UNITED STATES PATENT AND TRADEMARK OFFICE

Office Action Summary

10/000,147

DETAILED ACTION

quenching, and heating in two steps an aluminum-copper alloy (see Figure 1 below).

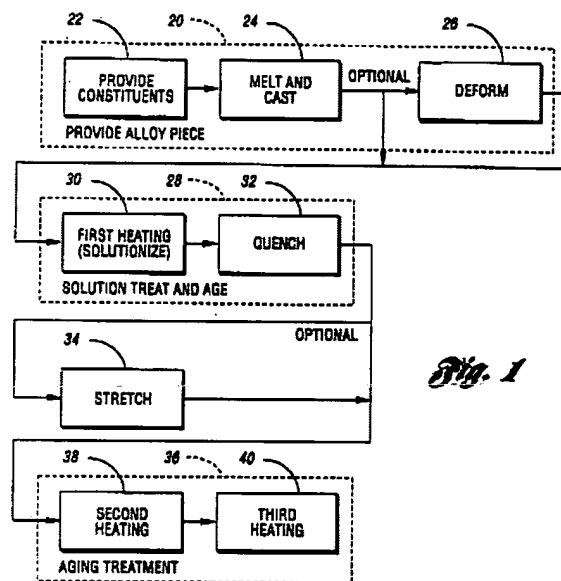
Waldron anticipates the claimed invention. Waldron teaches solution treating,

The first heating step involves aging for 8-30 hr at 120-140° C [248-284° F], and the second heating step involves aging for 10-20 hr at 150-170° C [302-338° F] (Claim 1). Regarding Claim 2, Figure 1 shows a step of stretching. Regarding Claim 3, Waldron teaches producing a heat-treated aluminum-copper alloy (column 2, line 8). Regarding Claim 4, the alloy contains lithium (Claim 1). Regarding Claim 5, the alloy contains Zr, Fe, and Mg (column 3, lines 6-10). Regarding Claim 6, the alloy contains Mg, Li, and Si (lines 7-10). Regarding Claim 7, the alloy contains Zr and Fe (line 9). Regarding Claim 8, the alloy contains 2.6-3.3% Cu (line 7). Regarding Claim 9, the alloy contains 2.6-3.3% Cu and 2.0-2.4% Li. Regarding Claim 10, the alloy contains Li, Mg, and Zr (lines 7-10). Regarding Claim 11, the solution treatment is 425-600° C [797-1112° F] (lines 37 and 38). Regarding Claim 12, the first aging is for 8-30 hr. Regarding Claim 13, the second temperature is 10-30° C [18-90° F] greater than the first
